#### Modification Bulletin

Model: CARIB-B (	Duplex Unit1000) for S-P1	e: 9-Jul-08		No.: MG176002									
Modified Article:	Interface Harness for Paper Fe	1	Prepared by: Y.Yoshida										
From: 1st Technical Support Sec. Service Support Dept.													
Reason for Modification:	☐ Parts catalog correction ☐ To facilitate assembly ☐ Part standardization	☐ Vend ☑ To im ☐ Other	prov	ange e reliability	□ To n	neet standards )							
Modification Schedule:

## **Part Change Information List**

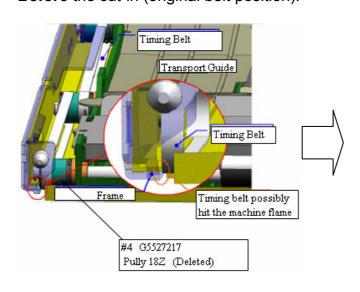
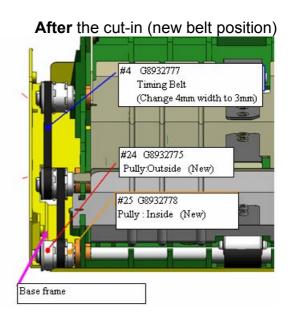
1) The width of the timing belts was reduced from 4mm to 3mm.

Note: The attachment position of the belts was reversed (see the photo below).

2) Due to this change, the pulley was separated into two service parts.

**Reason:** To ensure that the timing belt does not touch the machine frame.

Important: If you install the new parts on machines produced before the cut-in serial

number, attach the belt in its **original position** (left illustration).

Do not reverse the positions of the belts. This is because the frame was

modified to accommodate the new parts.

Cut-in Serial number: S0989200734

**Before** the cut-in (original belt position):
